# CPED STAFF REPORT

CPC Agenda Item #3  
 January 12, 2015  
 BZZ-6945

**Property Location:** 1611 East 46<sup>th</sup> Street  
**Project Name:** Hiawatha College Prep - Northrop  
**Prepared By:** [Mei-Ling Anderson](#), City Planner, (612) 673-5342  
**Applicant:** Charter Schools Development Corporation  
**Project Contact:** Dan Peterson, Edie Sebesta, & Mark Burgess, U+B Architecture and Design, Inc.  
**Request:** To allow a new, 45,429 square-foot building.  
**Required Applications:**

**LANDSCAPE PLAN**

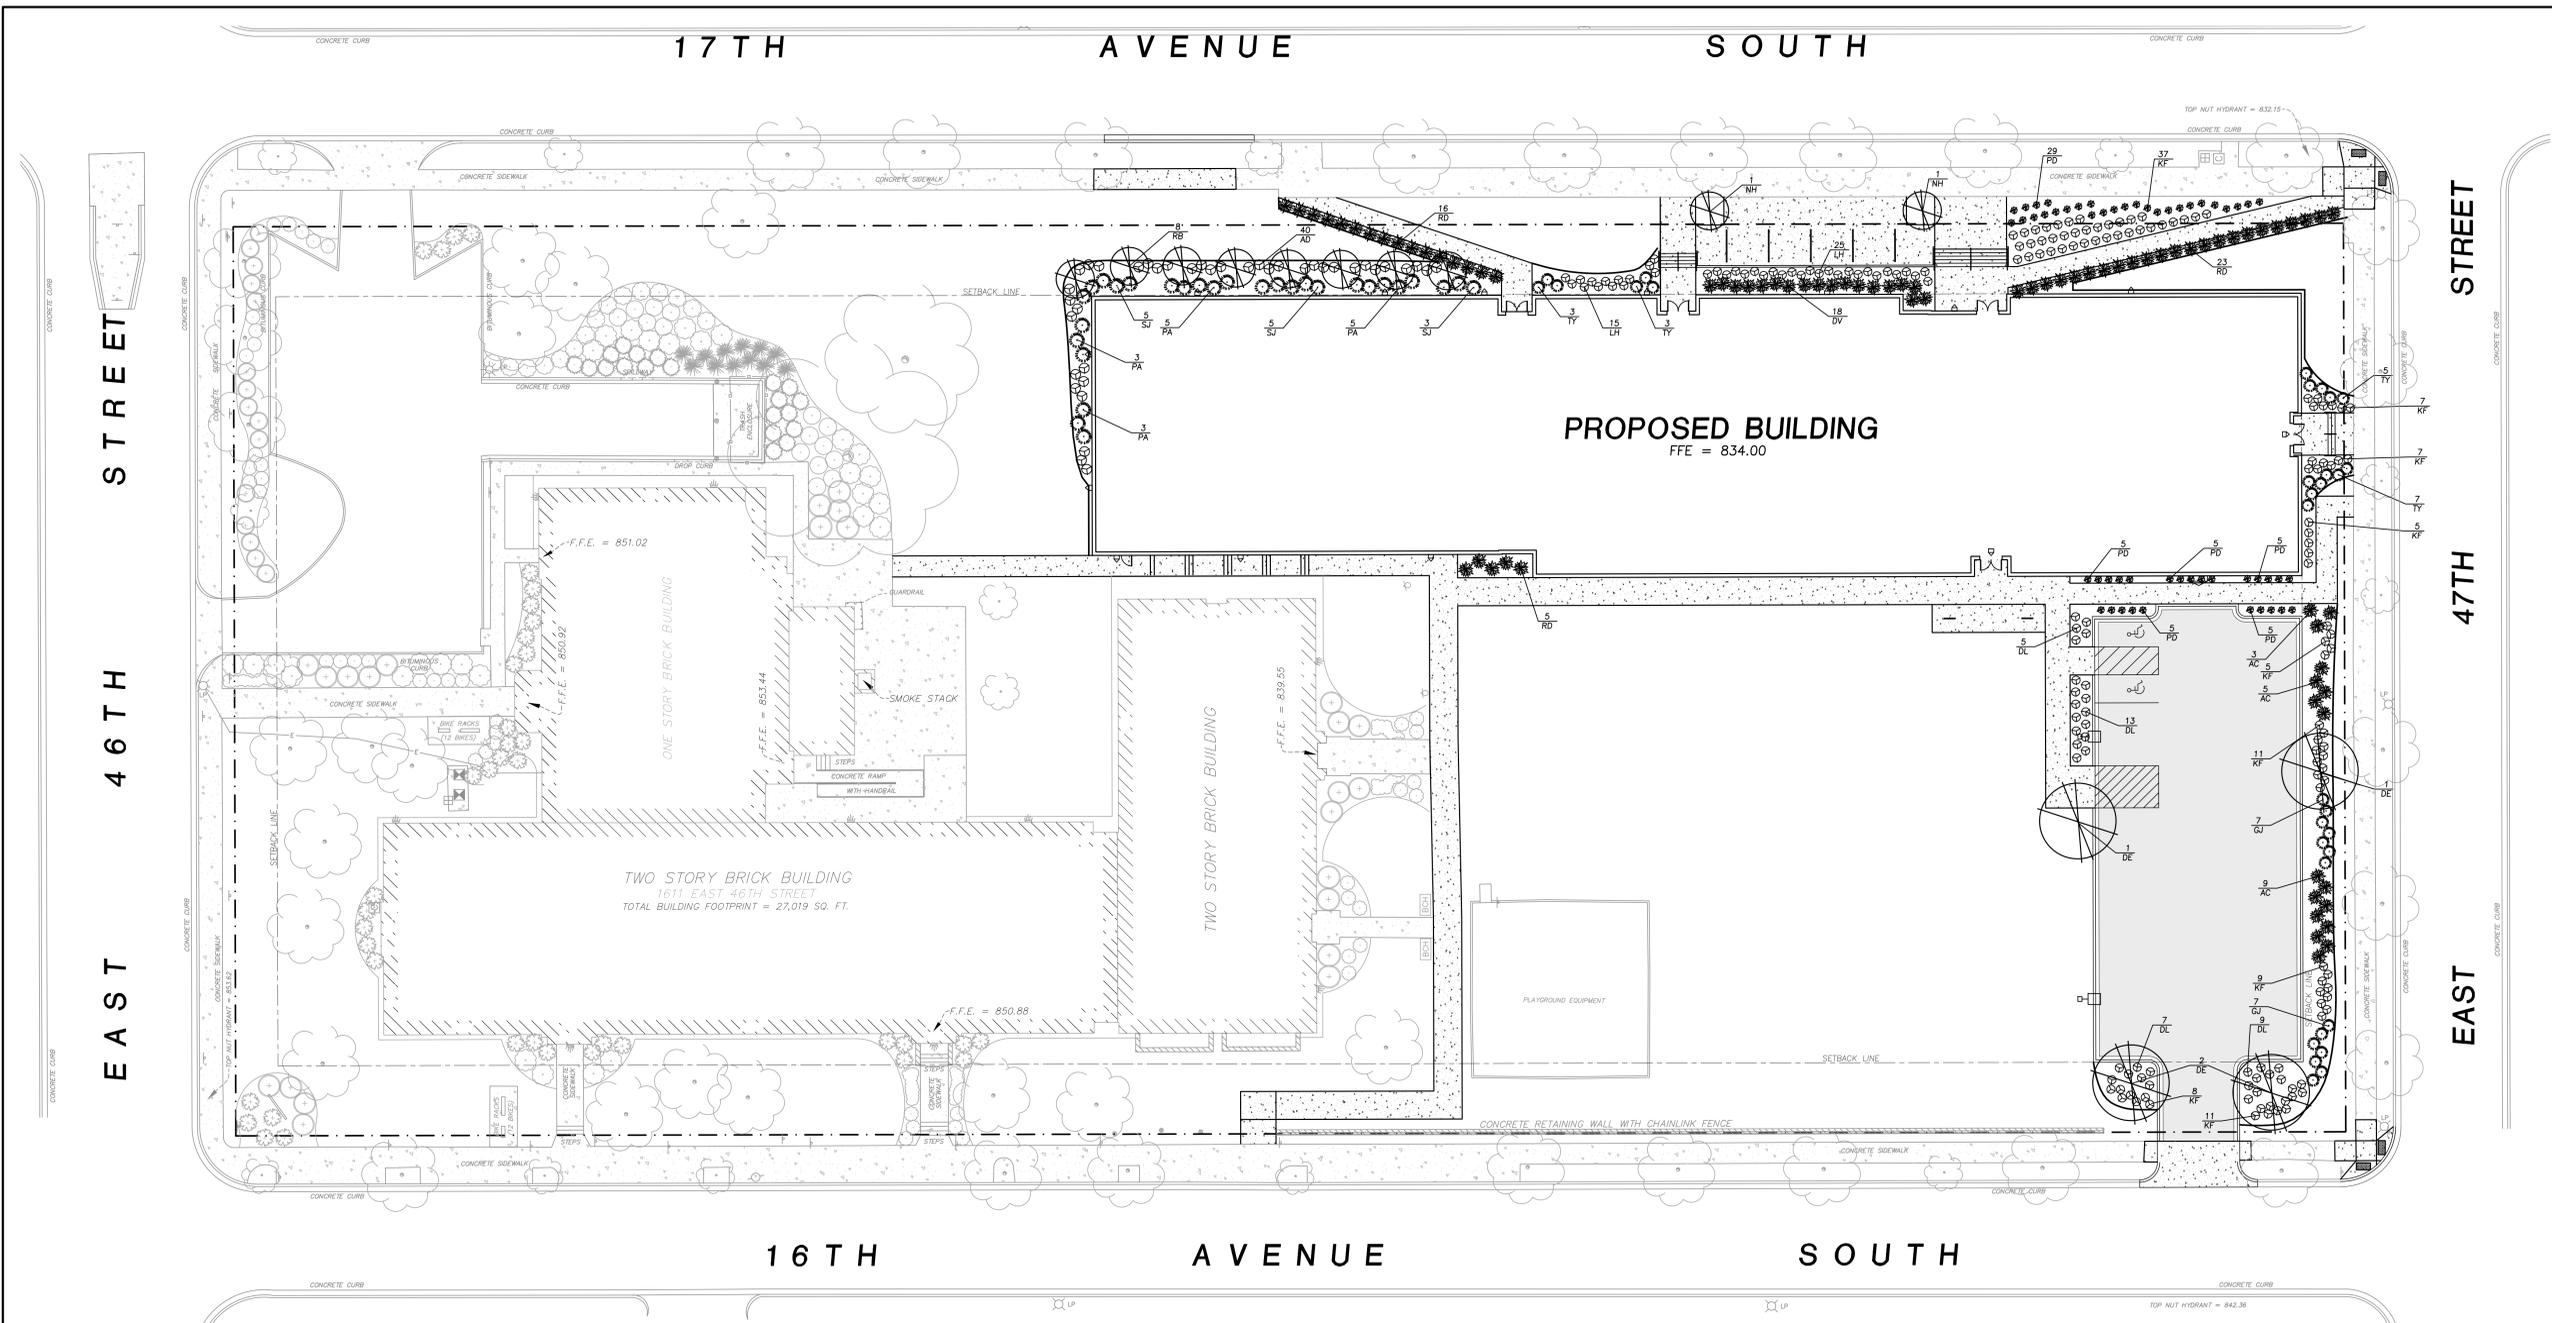
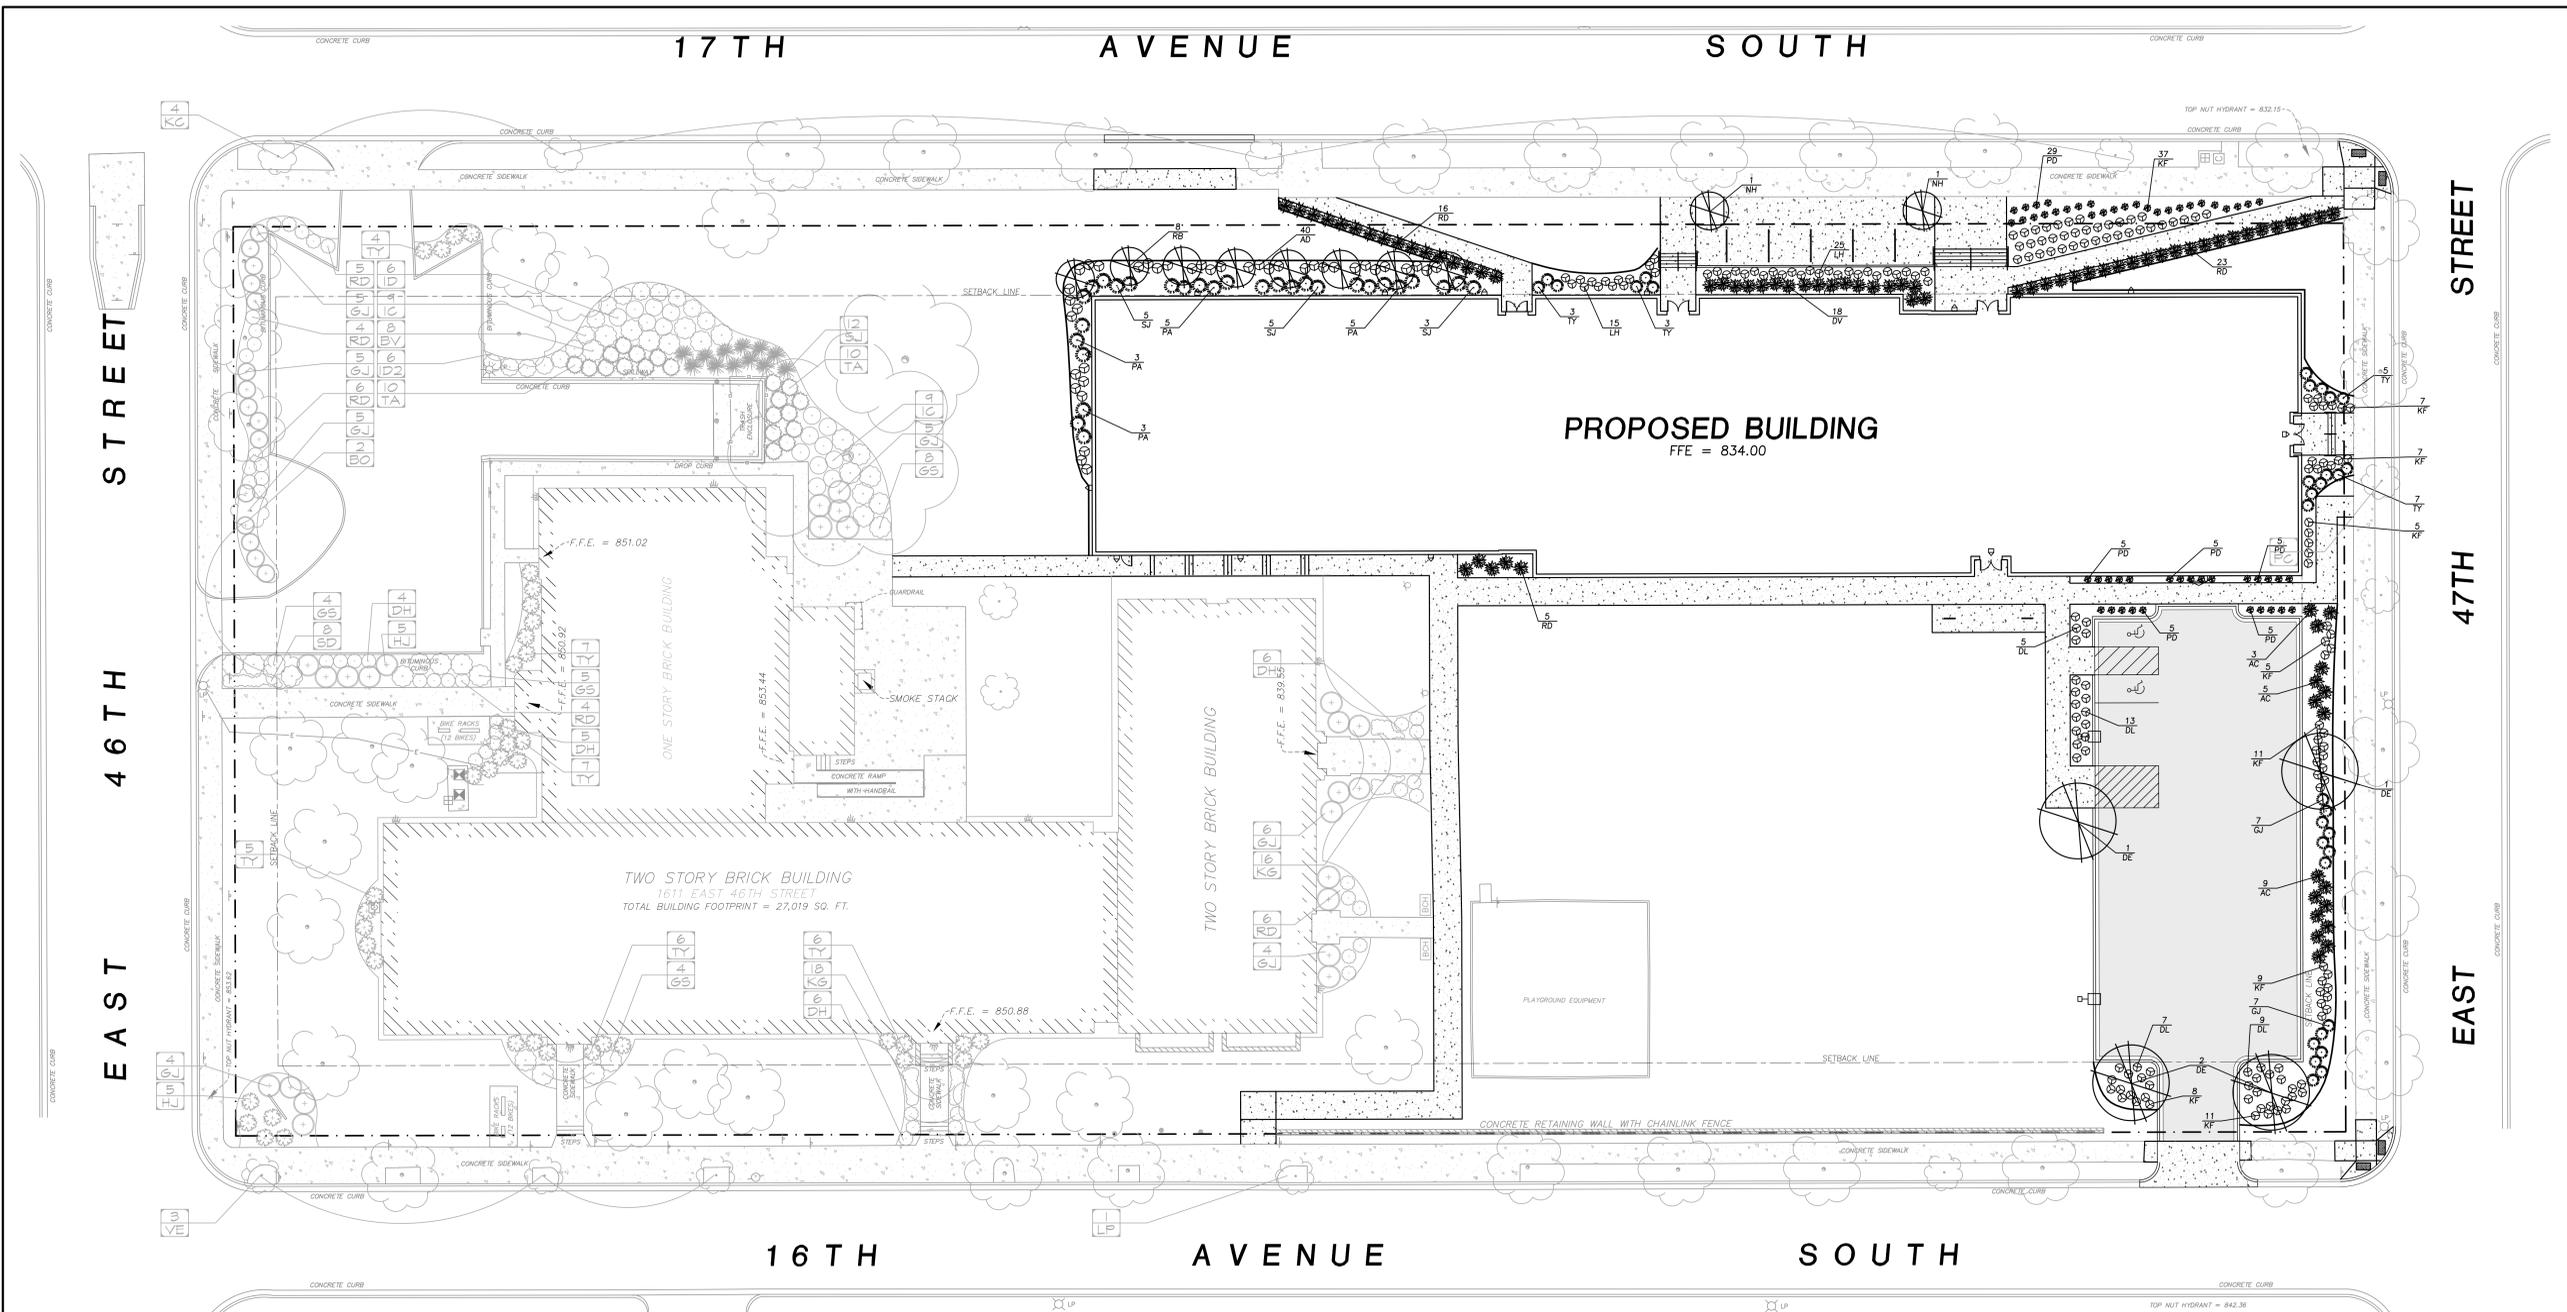
- The zoning code requires that the site contain at least one canopy tree per 500 square feet of required green space and at least 1 shrub for each 100 square feet of required green space. The tree requirement for this site is 41 and the shrub requirement is 202. There are 27 existing canopy trees. Six will be removed and 14 will be planted as part of the project, for a net increase of 8 and a total of 35. Alternative compliance is being requested for the minimum tree requirement, as six additional trees would be required.

- *47<sup>th</sup> Street East:* The width of the proposed landscaped yard between the parking area and property line is twelve feet, with approximately nine feet containing landscaping materials on the plans. Five on-site canopy trees are required along this parking lot frontage and two are provided. The proposed Karl Forester and Stella D'Oro Daylily plantings do not meet the year-round screening requirements, but the three-foot screen is met elsewhere along this frontage. Alternative compliance is requested for the screening and linear tree requirements along 47<sup>th</sup> Street East.

- *16<sup>th</sup> Avenue South:* The width of the proposed landscaped yard is 20 feet, which meets the minimum requirement. Two canopy trees are required and two are provided. The proposed Karl Forester and Stella D'Oro Daylily plantings do not meet the year-round screening requirements, but the three-foot screen is met elsewhere along this frontage. Alternative compliance is requested for the screening requirement along 16<sup>th</sup> Avenue South.

- **Landscaping requirements along 47<sup>th</sup> Street East.** Five on-site canopy trees are required along this parking lot frontage and two are provided. The proposed Karl Forester and Stella D'Oro Daylily plantings do not meet the year-round screening requirements, but the three-foot screen is met elsewhere along this frontage. Alternative compliance is requested for the screening and linear tree requirements along 47<sup>th</sup> Street East. Staff finds that it would be reasonable to require the applicant to comply with the minimum landscaped yard, screening and linear tree requirements along the 47<sup>th</sup> Street East parking lot frontage.

- **Landscaping requirements along 16<sup>th</sup> Avenue South.** The width of the proposed landscaped yard is 20 feet, which meets the minimum requirement. Two canopy trees are required and two are provided. The proposed Karl Forester and Stella D'Oro Daylily plantings do not meet the year-round screening requirements, but the three-foot screen is met elsewhere along this frontage. Alternative compliance is requested for the screening requirement along 16<sup>th</sup> Avenue South. Staff finds that it would be reasonable to require the applicant to comply with the screening requirements along the parking area on 16<sup>th</sup> Avenue South. In addition, staff is recommending a condition that requires the landscaping and screening materials on the northwest side of the proposed parking area be extended to the north to decrease the visibility of the parking area from the public sidewalk and surrounding residential uses.

5. The landscaping plan shall be consolidated into a single plan and plant schedule, and indicating that all areas of the property not covered by buildings, parking areas, or loading shall contain landscaping materials.

6. The landscaping plan shall demonstrate compliance with the minimum screening and linear tree requirements along the parking frontage areas on both 47<sup>th</sup> Street East and 16<sup>th</sup> Avenue South.

MATERIAL AREA CALCULATIONS  
EAST ELEVATION

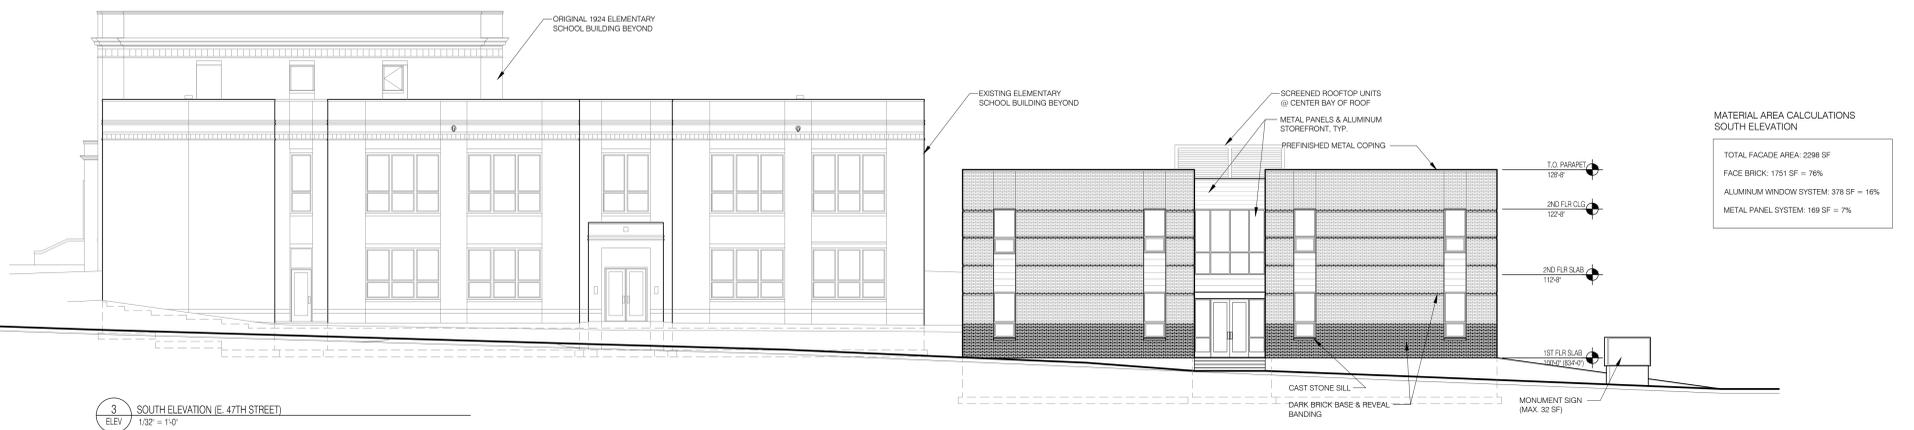
- While the exterior walls provide architectural details and windows to create visual interest and divide the building into smaller identifiable sections, the northern side of the east elevation would contain a blank wall exceeding 25 feet in length, which requires alternative compliance.

- **Blank wall.** While the exterior walls provide architectural details and windows to create visual interest and divide the building into smaller identifiable sections, the northern side of the east elevation would contain a blank wall exceeding 25 feet in length, which requires alternative compliance. This portion of the building would serve as the school's gymnasium, and the 32-foot blank wall would be opposite a storage area. As an alternative, the applicant is proposing extensive landscaping improvements on this side of the building to offset the impact of the blank wall. Staff recommends granting alternative compliance.
